# FORT ORD REUSE AUTHORITY

## REGIONAL URBAN DESIGN GUIDELINES (RUDG)

# REGIONAL URBAN DESIGN GUIDELINES (RUDG) TASK FORCE MEETING

Summary of Comments on FORA-  
PublicReviewDraft\_RUDG\_051616\_WatsonCommentsC.pdf

Avenue Option 1: Bike Lanes Street Section

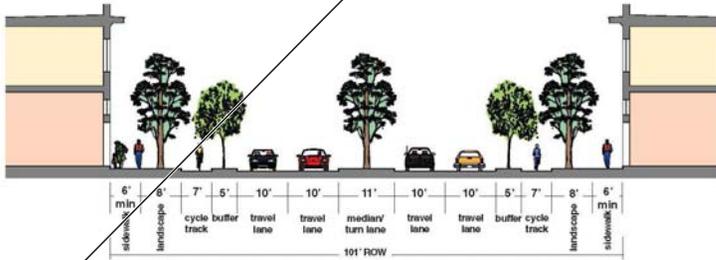
Author: Fred Watson Subject: Highlight Date: 5/27/2016 9:50:23 AM  
 Somewhere (perhaps here?), there should be guidelines for what happens to bikes (and joggers) when through-flow streets cross smaller streets. There should be guidelines for things like cross-walks for bikes, so that bike flow is not interrupted by having to stop when crossing the smaller streets (Imjin Parkway at present is an example of how NOT to do this well, it has inappropriately frequent signs directing cyclists to dismount and walk across minor streets). These guidelines could include specifications about the maximum frequency with which crossings would occur that would potentially necessitate a full stop on a bicycle (e.g. no more than once per half-mile).

Author: Fred Watson Subject: Highlight Date: 5/27/2016 9:51:47 AM  
 Should state in words (not just pictures) that cycle-tracks should have physical separation (g. trees, as illustrated).  
 (GJM Bvd near Broadway is an example of how NOT to do this well. There is a large sidewalk with unsafe separation - i.e. just a curb, that a child could easily fall over. GJM would work better if it had vegetation between the curb and the sidewalk)

**Boulevard Street Section**

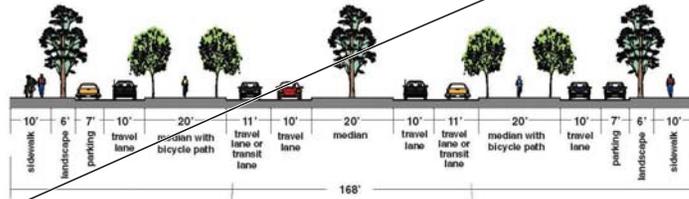
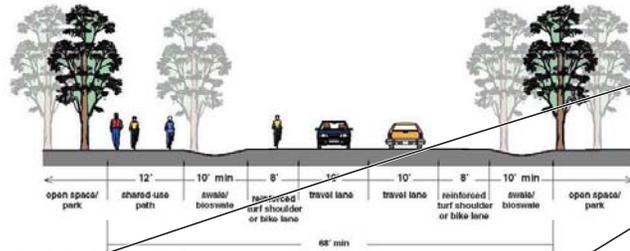
Author: Fred Watson    Subject: Highlight    Date: 5/27/2016 6:00:37 AM  
Should state in words (not just pictures) that bicycles in medians should have physical separation (e.g. trees, as illustrated).

Figure 3.57: Rural Corridor Trail

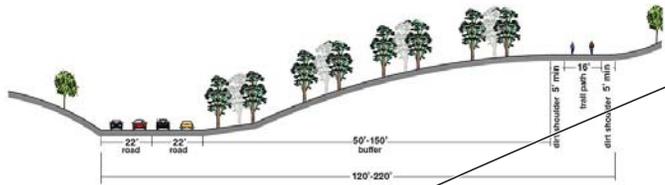
Perhaps the simplest change is to clarify that the 20-foot includes not just the tread but also the physical separation elements. Typically, an equestrian trail has a tread about 6-feet wide, and a separation area (shrubs etc.) that might extend 7-feet either side of that.

Figure 3.59: Urban Corridor Trail

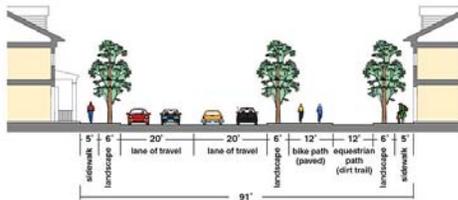
Author: Fred Watson    Subject: Highlight    Date: 5/27/2016 7:58:33 AM  
 the text on the diagram excludes long-distance pedestrians like joggers from the trail system  
 the trail system (not the sidewalks) is depicted as serving bikes and equestrians, but not walkers/hikers/joggers etc.  
 maybe the text in the diagram needs a minor edit to be more inclusive

**Option 2. Military insignia – private first class**

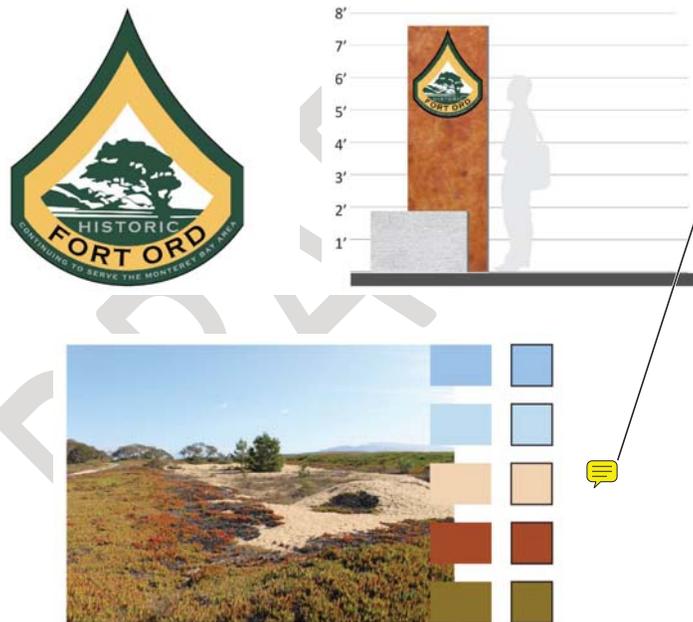
Author: Fred Watson  
misfit? Subject: Sticky Note Date: 5/27/2016 8:44:44 AM

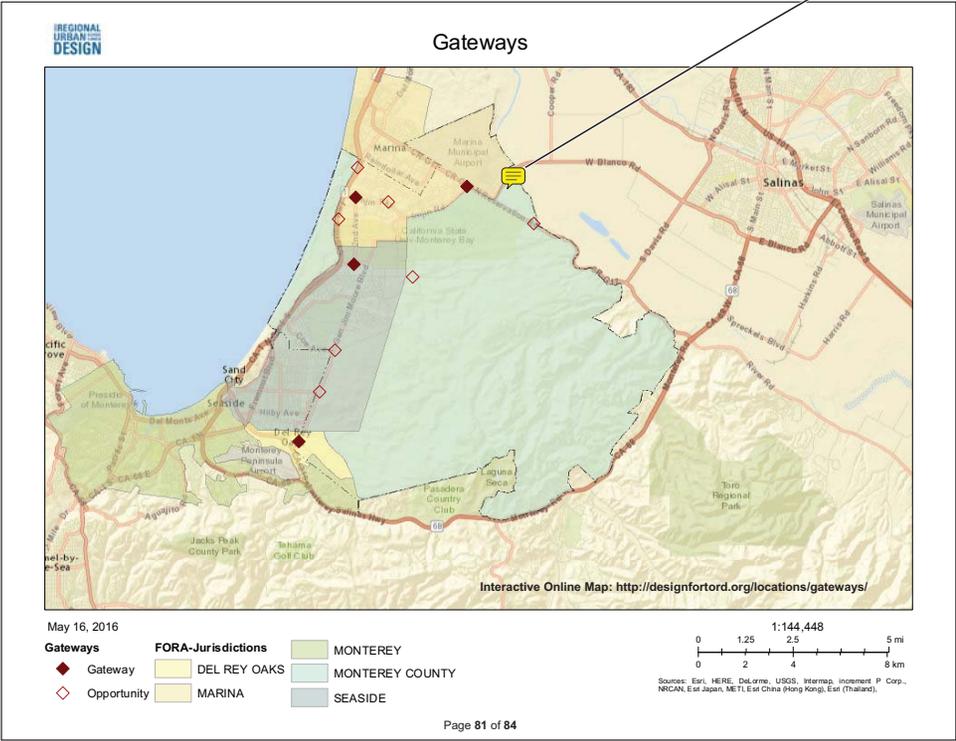
Author: Fred Watson    Subject: Sticky Note    Date: 5/27/2016 9:24:02 AM  
The Imjin/Reservation gateway would be better placed at the Blanco/Research intersection, to reflect the opportunities for substantial base reuse elements to occur either side of Blanco i.e. BEFORE the westbound traveller reaches the Imjin/Reservation intersection.  
This idea was expressed during the RUDG public events, but has not been reflected here.

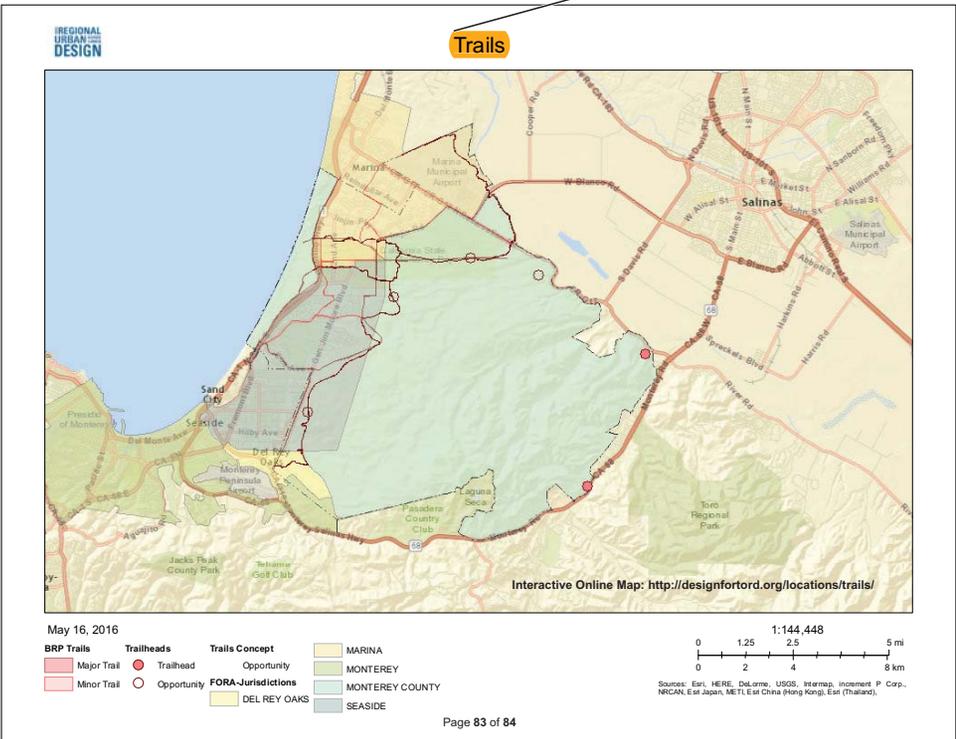
Author: Fred Watson Subject: Highlight Date: 5/27/2016 9:31:44 AM  
 This map reflects that which was approved by the FORA board in March 2016 as the "Draft Trails Concept".

But this concept is a living thing, the most up-to-date version of which should be reflected in any subsequent documents (like the RUDG) to be submitted for FORA Board approval.

Given this, I have several "updates" that I can provide, all of which have benefitted from substantial public involvement and agency consultation.
